**Permit Application Review Report**  
**Date: 10/21/2026**

**Project Name:** North Metro Storage

**Project PAN:** P-26-033

**Project Purpose:** storage building additions and stormwater management feature

Figure 2: Site Plan

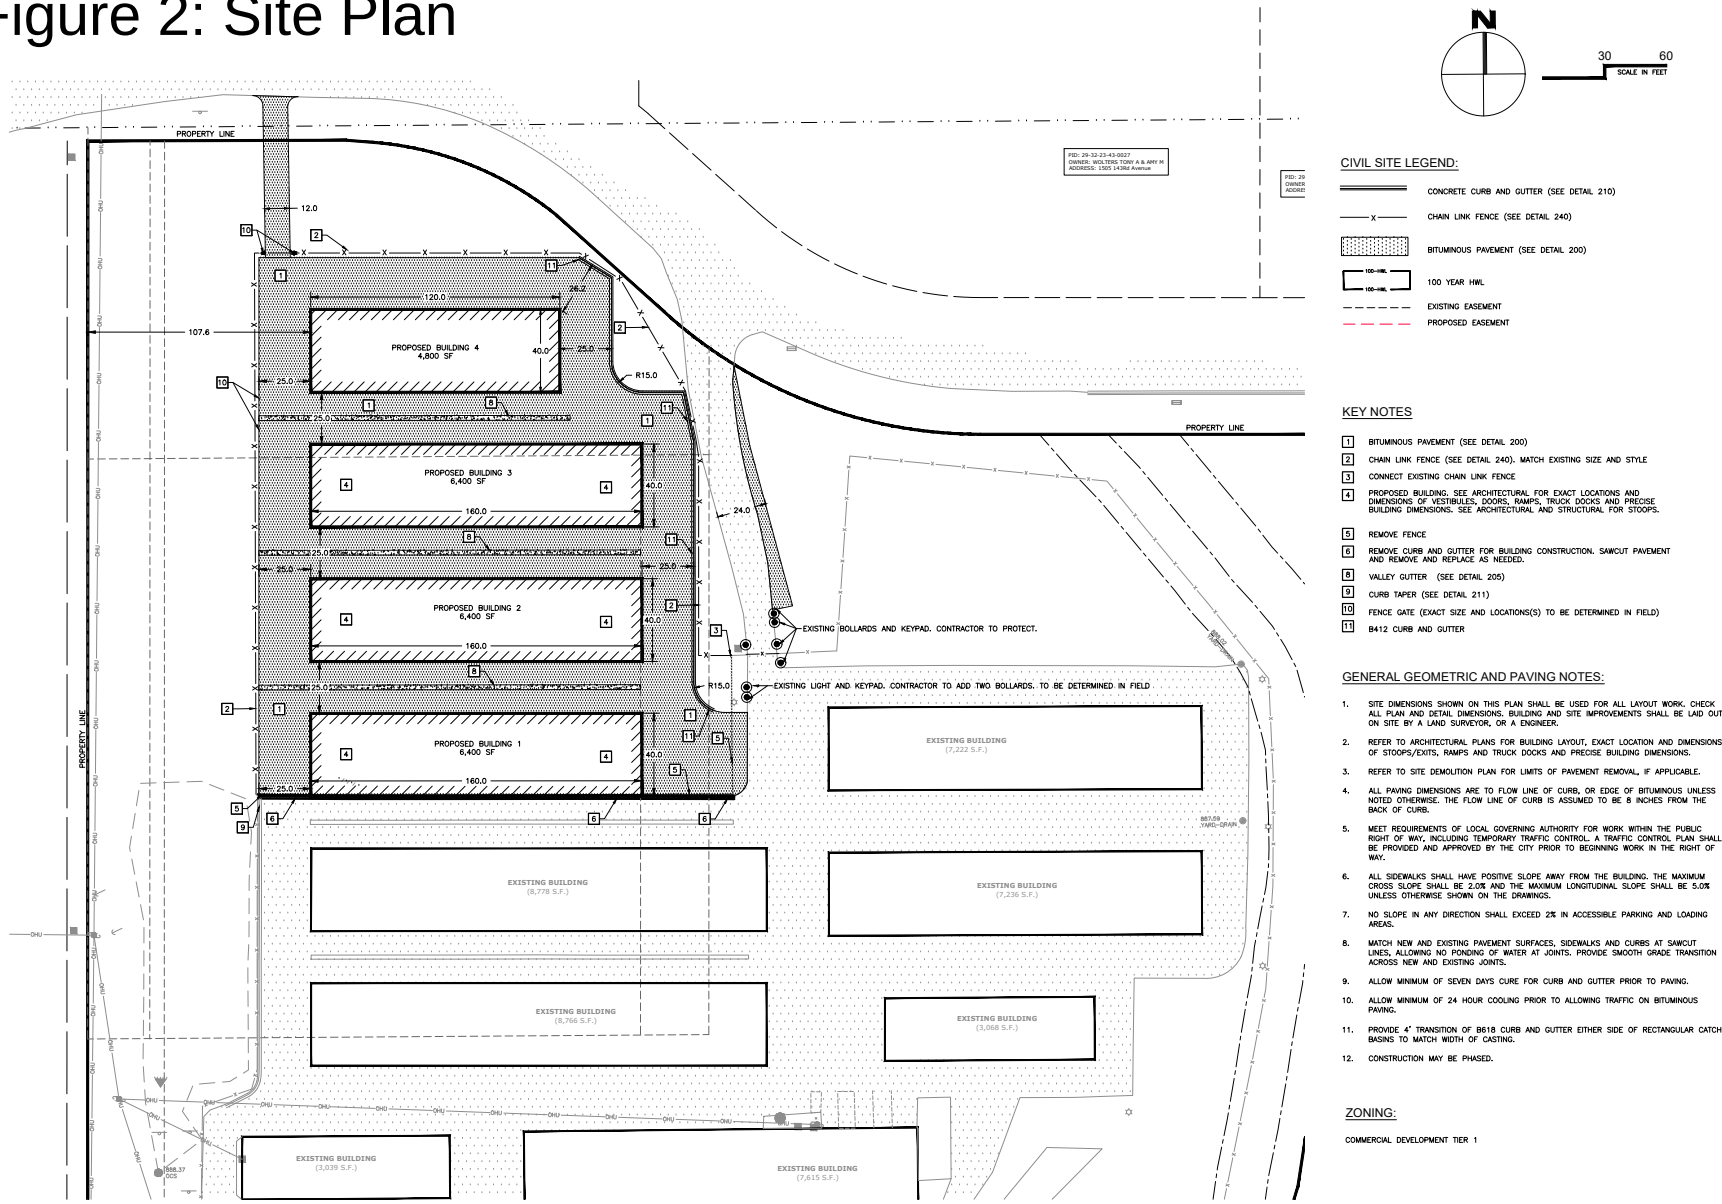
**Description:** North Metro Storage is proposing an expansion which includes new storage buildings, driving aisles and a stormwater pond expansion. The project will disturb 2.3 acres and create 1.25 acres of new impervious. The parcel drains to County Ditch 59. The relevant water resource concerns are stormwater management (District Rule 3), Soils & Erosion Control (District Rule 4) and Floodplain (District Rule 6). See attached Figure 1: Project Location and Figure 2: Site Plan.

Figure 3: Soils & Erosion Control

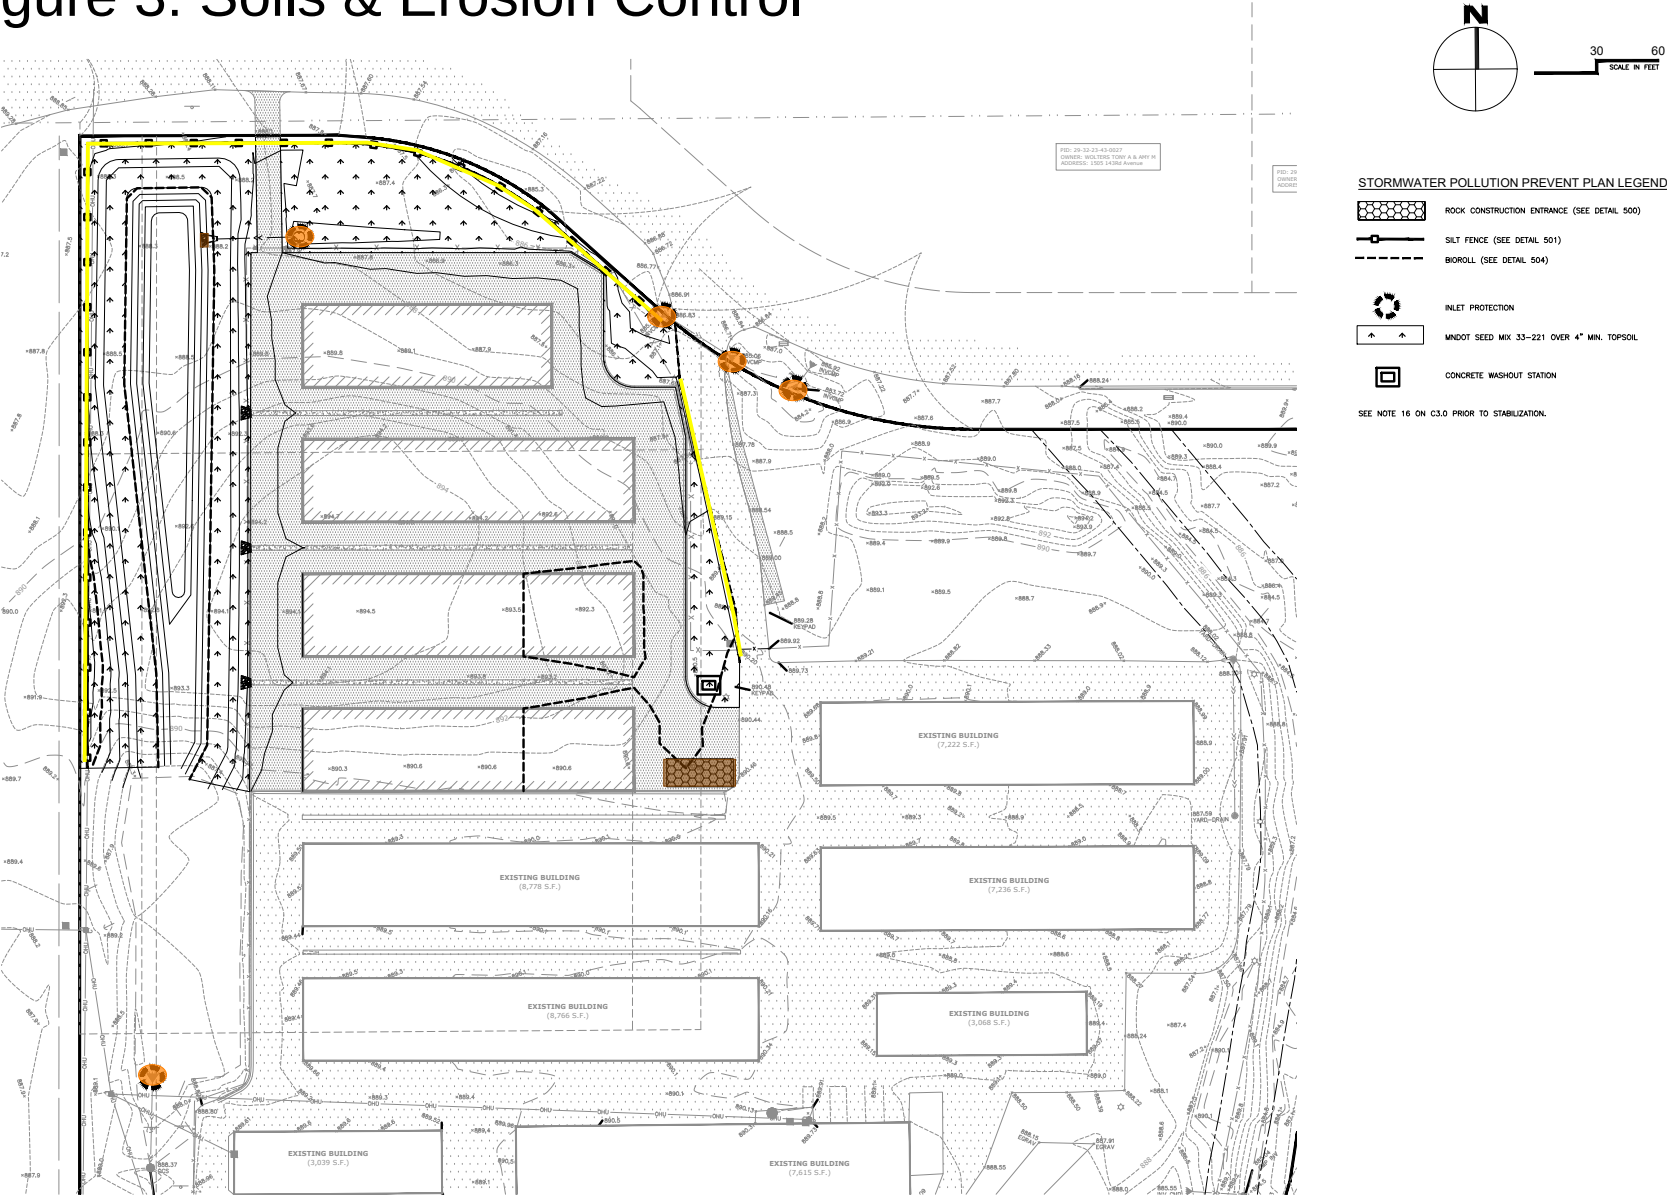
4. Update the soils and erosion control plan to include the following:
  - a. include a note to stabilize soils and soil stockpiles within 24 hours of inactivity.

- b. include standard details for concrete washout and inlet protection.

The proposed project drains to Ditch 59. The soils affected by the project include Lino and Zimmerman and have a soil erodibility factor of 0.15 or greater. Disturbed areas are not proposed to be stabilized within 24 hours, as required. The proposed erosion and sediment control plan includes perimeter control, stabilized construction entrance, inlet protection, and street sweeping. The erosion control plan does not meet District requirements because concrete washout and inlet protection standard details have not been provided, and soils and soil stockpiles are not proposed to be stabilized within 24 hours of inactivity. The site does require an NPDES permit. See attached Figure 3: Soils & Erosion Control.

Figure 4: Floodplain Impact

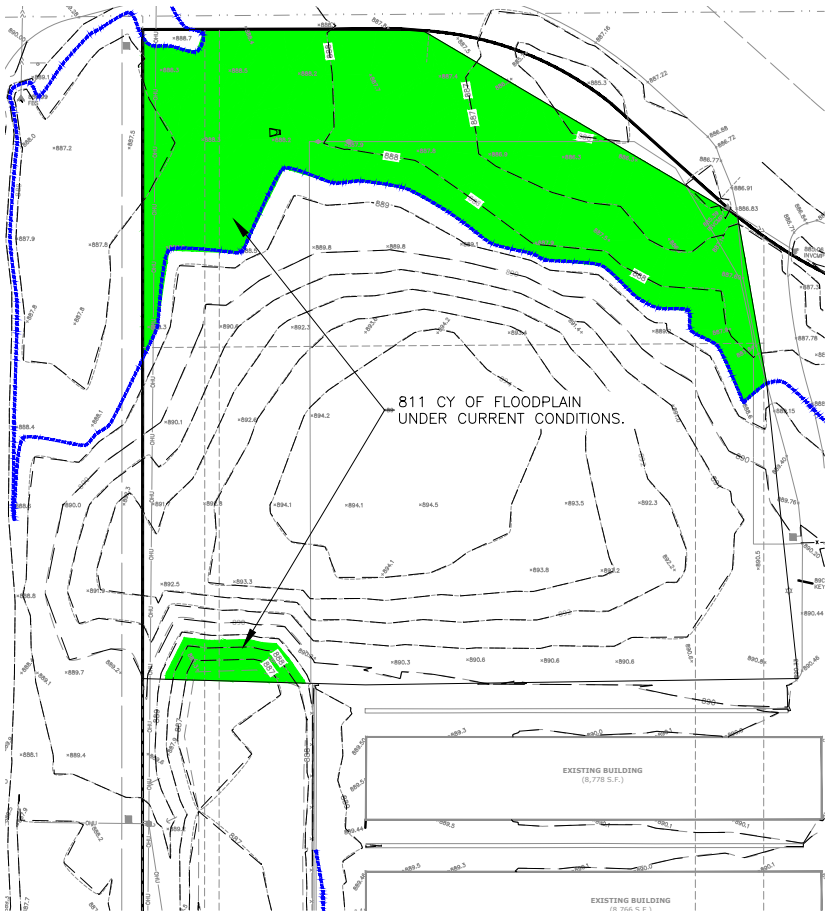
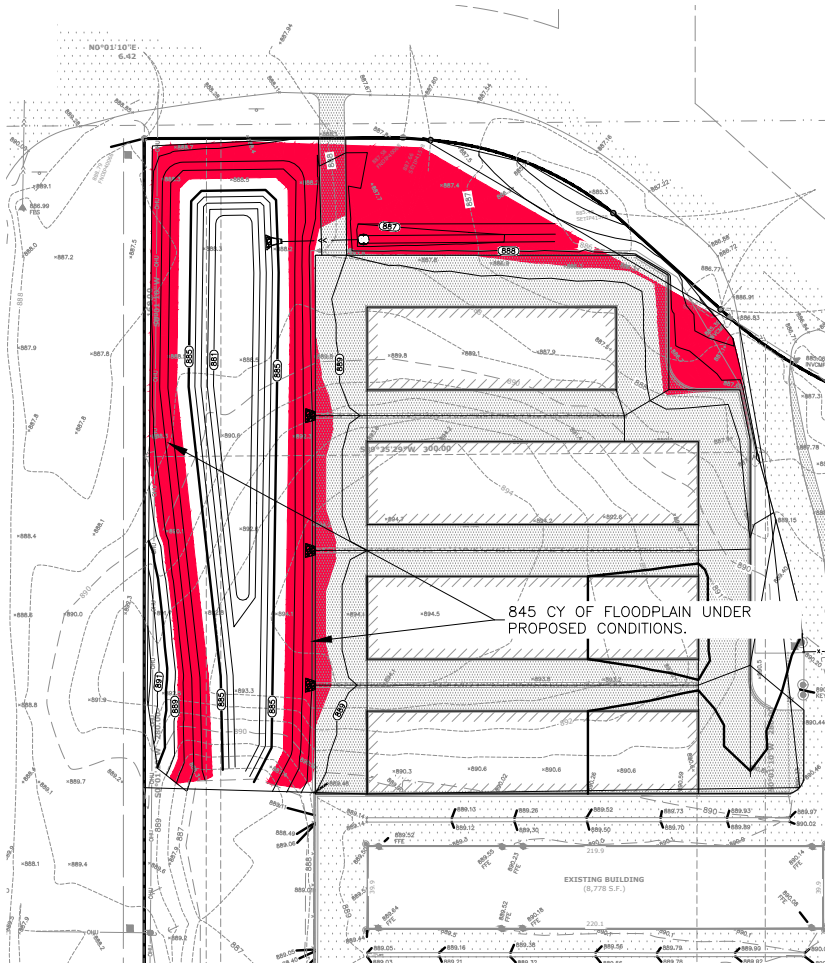
The regulatory floodplain elevation is 888.6 NAVD 88. The application proposes the placement of 696 cubic yards of fill within the floodplain. Compensatory storage is required. The proposed project provides 730 cubic yards of compensatory storage, which exceeds the required 1:1 ratio and is within the relevant reach. See attached Figure 4: Floodplain Impact/Mitigation.

1. Submittal of grading as-builts for the project to confirm adequate floodplain compensatory storage has been provided.
2. The applicant must apply for coverage under the Minnesota Pollution Control Agency's (MPCA's) Construction Stormwater Permit (Permit No: MNR100001)
3. If dewatering is required, provide DNR dewatering permit prior to construction. If a DNR permit is not required, provide well-field location, rates, discharge location, schedule and quantities prior to construction.
4. Submittal of as-builts for the stormwater management practices and associated structures listed in Table 2, including volume, critical elevations and proof of installation for hydrodynamic separators.
